Re: Busconnects Galway: Dublin Road Development, Compulsory Purchase Order No BCGDR-CPO-001-2025
Dublin Road, County Galway

**BusConnects Dublin Road
Galway Planning
Application & CPO
Submission on behalf of
HSE – Merlin Park
University Hospital
Campus**

ABP Pl. Ref.321776 &
CPO Case Ref: 321882

Figure 1: Drawing no. BC'GDR-BTL-GEO_GA-XX-DR-CR-000006, as prepared by RPS.

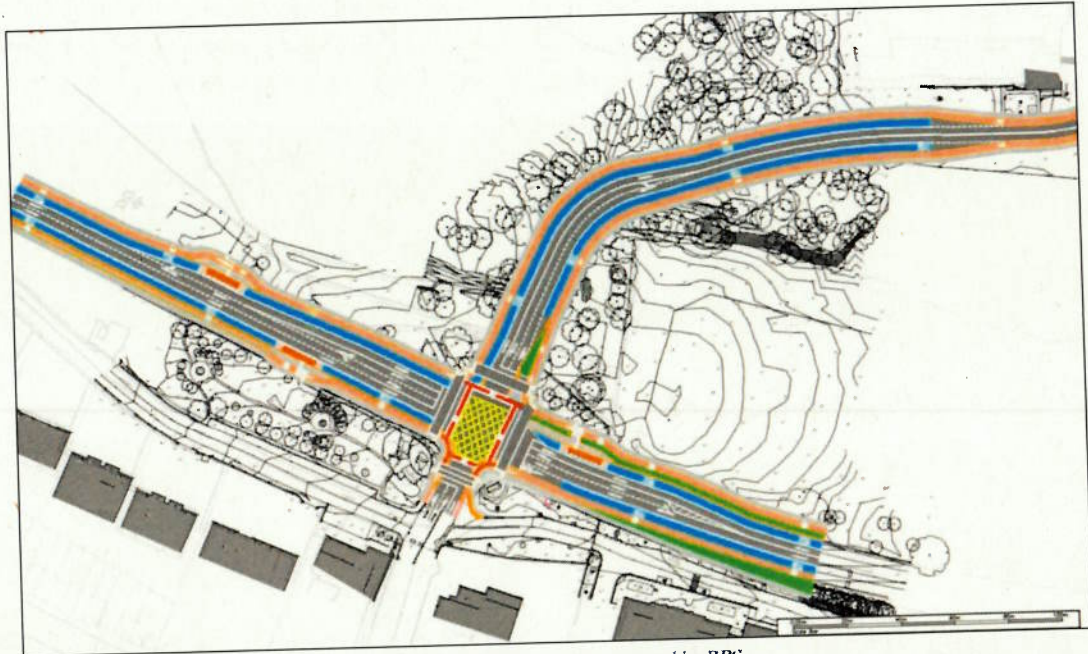
The HSEs engineering advisors have prepared a preliminary design for a fully upgraded junction. This design exercise has identified specific deficiencies in the design proposal, which is the subject of this planning application, as follows:

- The Bus Connect Schemes and potential CPO does not allow for Right turning lane from the East and left turning lane from the west;
- The proposed location of the Bus Lane in the East direction (on the northern side of the Dublin Road) currently clashes with RPS straight through Lane at the proposed new access to Merlin Park;

- The proposed bus stop on the east bound bus lane (on the northern side of the Dublin Road) clashes with RPS proposed Left turning lane. RPS proposal positioned this further to the West to facilitate the potential required length of lanes;

- Placing of concrete build outs (civil structures / kerbing / paving) will require moving if the junction is upgraded to a 4 arm at a later date;
- Utility diversion/extensions will be required depending on service locations etc.;

As indicated in Figure 1 above, the HSE's advisors have prepared a fully upgraded junction design to include the BusConnects project and the provision of a fourth arm to service the Merlin Park Campus. There are a number of engineering requirements involved in providing a fourth arm and changes required to the proposed Busconnects design including the provision of a left hand turning lane into MPUH on the east bound lane of the Dublin Road, the provision of a right hand turning lane into MPUH on the west bound lane of the Dublin Road, reposition of bus lane in the east direction, reposition of the bus stop on the east bound lane, utility diversions/extensions, altering of road markings and signage etc. These requirements will require additional land take than what is currently identified by GCC and the NTA. Figure 3 below indicates the extent of the RPS anticipated CPO line which accommodates a 'futureproofed' Dublin Road/Galway Crystal junction in comparison to the GCC & NTA proposed CPO line.

Figure 3: Drawing no. IE001123-RPS-00-XX-DR-C-SK0003 BusConnects Overlay -02, as prepared by RPS.

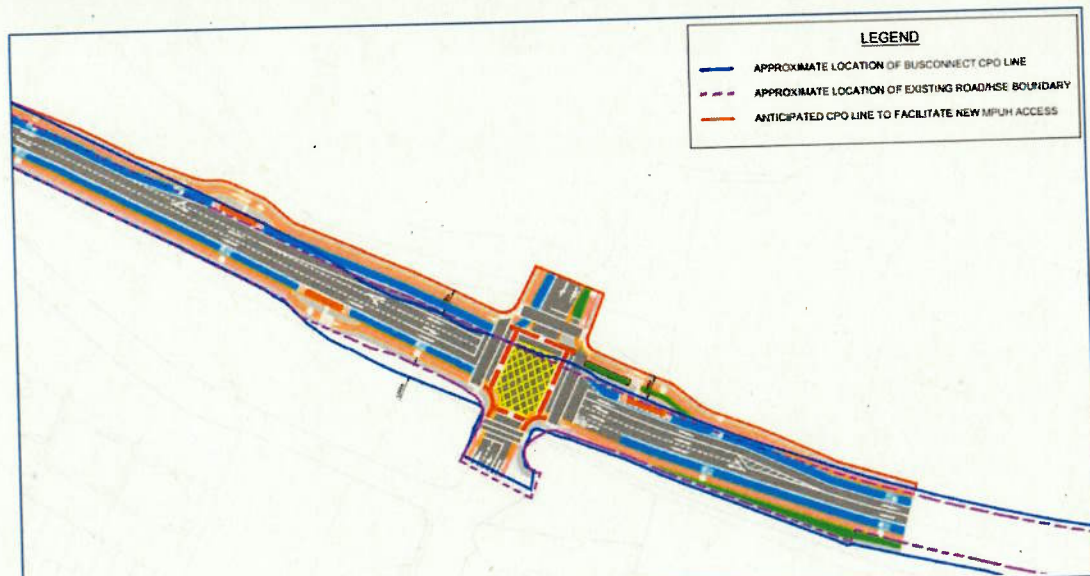
These drawings highlight the engineering requirements involved in providing a fourth arm, in particular the left and right hand turning lanes and the additional land take required. The HSE ask that the CPO land take is reviewed in relation to the extent of land take proposed as part of the CPO relative to the extent of works that would be required to adequately 'future proof' the Dublin Road/Galway Crystal junction.
